TECHNICAL SERVICE BULLETIN

Stuck In Park, "Service Vehicle Soon" Message In The IPC, Illuminated Powertrain Malfunction (Wrench) Indicator With DTC P07E6:71 Stored In The SOBDMC

26-2421

This bulletin supersedes 25-2622. Reason for update: Updated the Service Procedure to remove step related to connecting a battery charger, add Steps 7 and 29, add Figure 4, updated part list to include rear electric drive assembly stud bolts and nuts to secure the mass damper

Figure 4

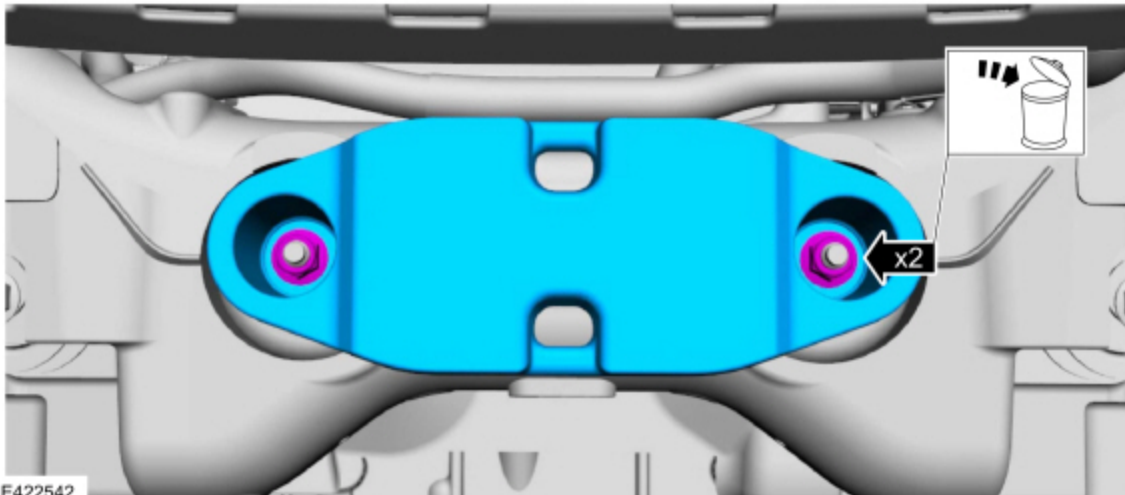
7. Is the vehicle equipped with a mass damper as shown in Figure 4?

(1). Yes - remove and discard the nuts, remove the mass damper.

(2). No - proceed to Step 8.

29. If equipped, install the mass damper and the nuts. Tighten the nuts to 81 lb-ft (110 Nm).
 30. Remove the powertrain lift table and the wooden blocks.
 31. Position back the wire harness and install the nuts. Tighten the nuts to 97 lb-in (11 Nm). (Figure 24)
- Figure 24
